AMENDMENT UNDER 37 C.F.R. § 1.111  
U.S. Application No. 10/511,084

**AMENDMENTS TO THE DRAWINGS**

### REMARKS

FIG. 3A

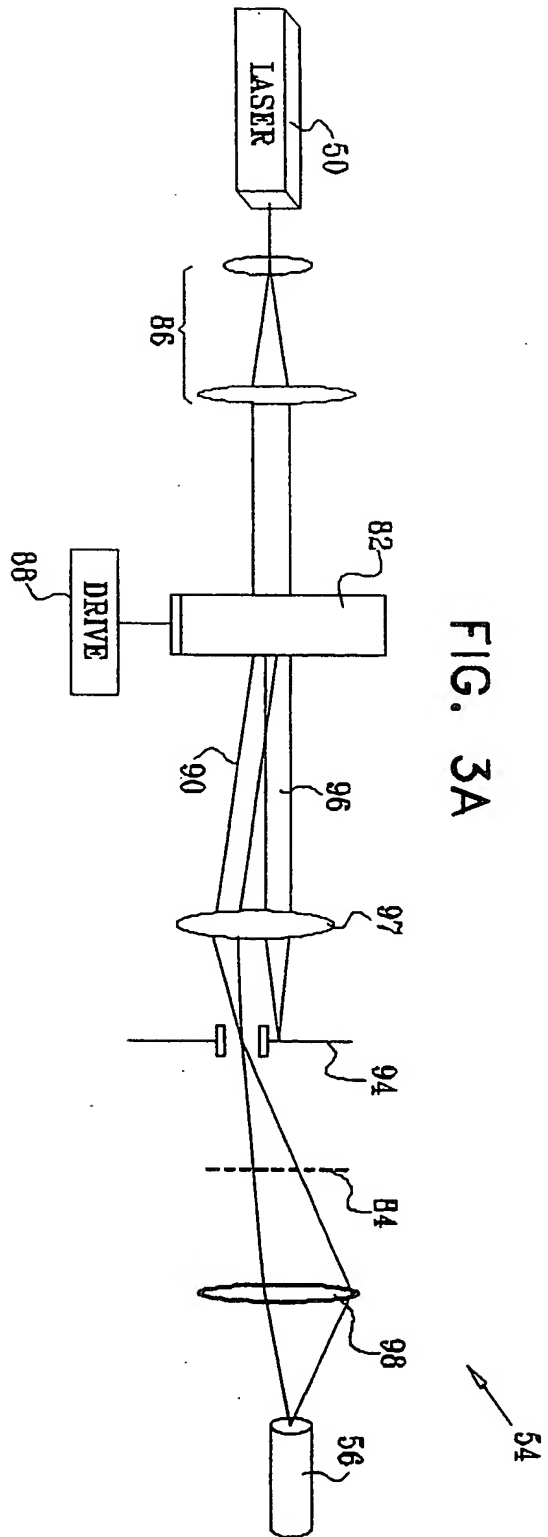
Drawing sheet number 3 containing Figure 3B has been amended. Specifically, numeral 54 , designating a speckle reduction module, has been changed to “54”.

Specifically, objection to Figures 3A and 3B is made for allegedly failing to comply with 37 CFR 1.8(p)(5) because reference character "54" has been used to designate both the optical

system in Figure 3A and the optical system in Figure 3B. Applicants respectfully submit that this objection is fully overcome by the present amendment of Figure 3B.
